RIVERSIDE – REPLACEMENT DWELLING DRAINAGE – FOR PLANNING DOC

Drainage Information for Proposed Replacement Dwelling & Outbuildings

Revision P7

Our Reference
23-040

Title
SITE DRAINAGE PLAN

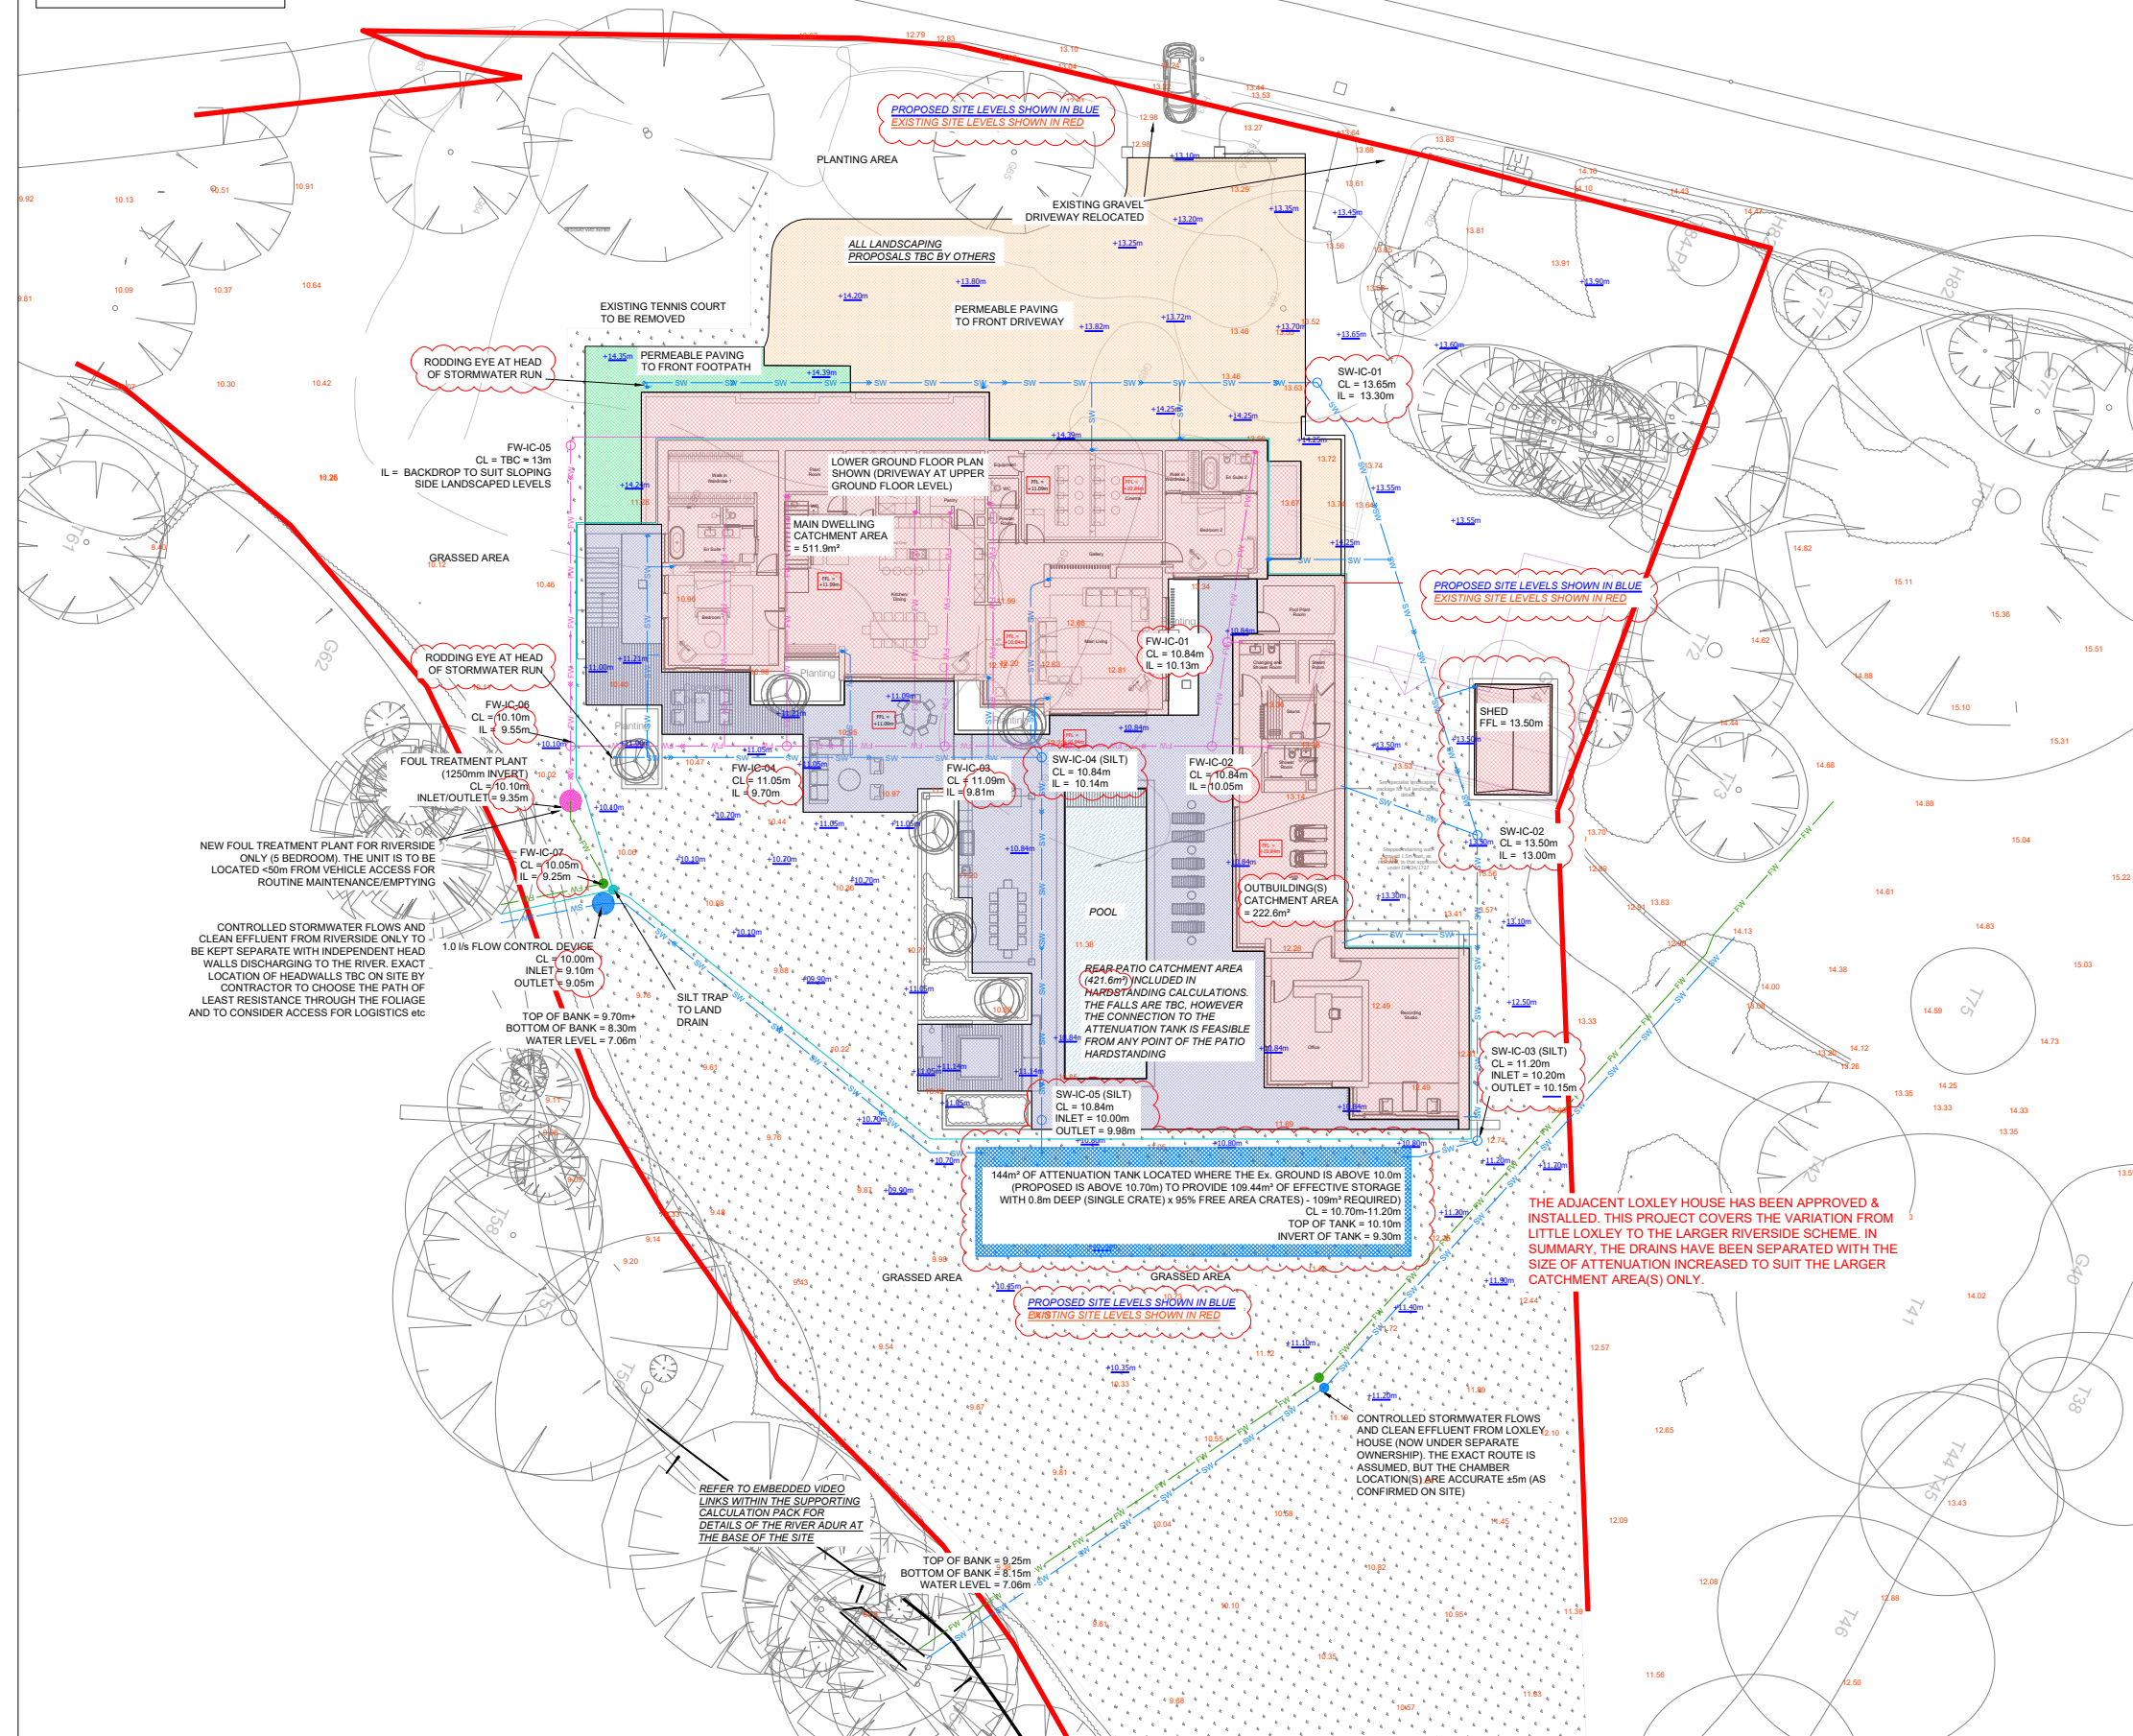
P7 – THIS ISSUES COVERS THE ADDITION OF THE OUTBUILDINGS AND THE UPDATED LANDSCAPING LEVELS FOR RIVERSIDE. THIS REPRESENTS A NOMINAL INCREASE IN TOTAL CATCHMENT AREA THAT REQUIRES AN INCREASE FROM 102m³ OF ATTENUATION TO 109m³ OF ATTENUATION TO LIMIT THE NEW FLOWS TO 1l/s.

ONLY DRAWING 51 IS UPDATED WITH ALL CHANGES CLOUDED. THE NEW CALCULATIONS ARE INCLUDED WITHIN SECTION C.

REV	DESCRIPTION	DATE	BY
B1	DOC / BUILDING REGS	25.07.2023	PW
B2	RIVERSIDE ATTENUATION INCREASED TO SUIT 45% CC	27.09.2023	PW
P6	RIVERSIDE ATTENUATION INCREASED TO SUIT LARGER VOC ROOF & REAR PATIO CATCHMENT AREAS	09.07.2024	PW
P7	OUTBUILDINGS ADDED & LANDSCAPING LEVELS UPDATED (ATTENUATION REQ INCREASES FROM 102.2m³ TO 109m³). TANK LOCATION RELOCATED TO HIGHER GROUND LEVEL(S)	13.12.2024	PW

PROPOSED CATCHMENT AREA
PROPOSED MAIN DWELLING ROOF = 511.9m²
PROPOSED OUTBUILDING(S) = 222.6m²
PROPOSED REAR PATIO(S) = 421.6m²
PROPOSED SHED = 13.50m²
PROPOSED TOTAL CATCHMENT AREA = 1175m² (0.1175ha)
PROPOSED RIVERSIDE SITE AREA = 6378.4m² (0.63784ha)

REQUIRED ATTENUATION VOLUME TO LIMIT FLOW RATES TO 1.0 l/s IS = 109.0m³

PROPOSED SIZE IS 24m LONG x 6m WIDE x 0.8m DEEP & LOCATED WHERE THE GROUND LEVEL IS ABOVE 10.70m. THIS PROVIDES 109.44m³ OF EFFECTIVE STORAGE WITH 95% FREE AREA CRATES.

Rainwater / storm attenuation design

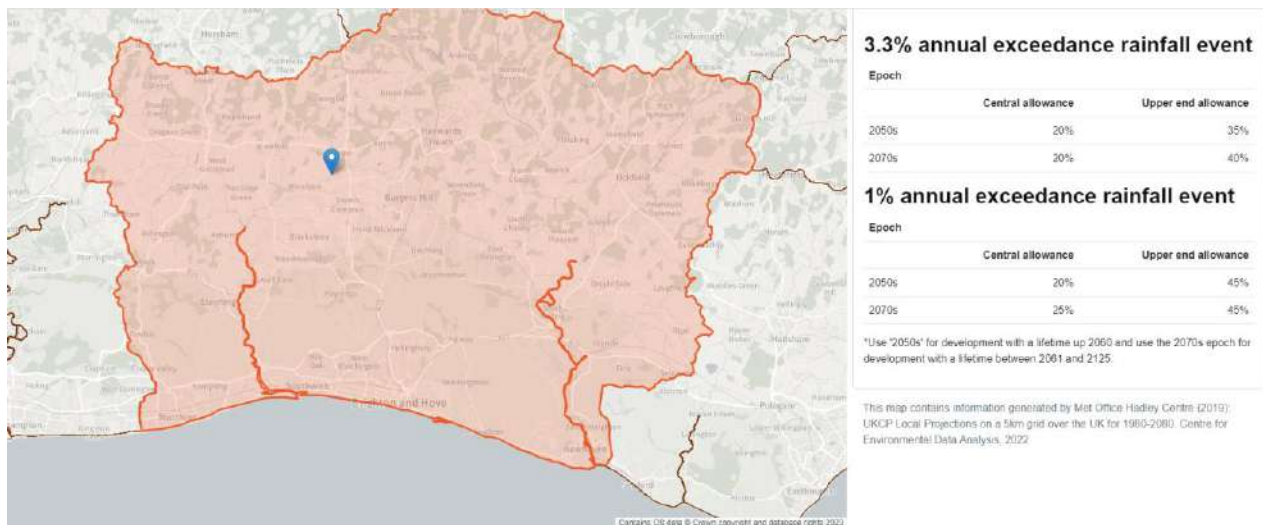
Proposed Total Catchment Area = 1175.0m² (0.1175ha) revP7 – THIS IS A 47.9 m² INCREASE

IN LINE WITH LATEST GOV.UK PEAK RAINFALL INTENSITY, THE PROPOSED ATTENUATION HAS BEEN INCREASED TO SUIT THE 45% CLIMATE CHANGE FACTOR & THE LARGER CATCHMENT AREAS. THIS RESULTS IN AN INCREASE FROM 102.2m³ TO 109m³

Required attenuation to limit flow rates to 1.0l/s is ~~102.2m³~~ 109m³

Proposed size is 24m long x 6m wide x 0.8m deep & located where the ground level is above 10.70m. This provides 109.44m³ of effective storage with 95% free area crates
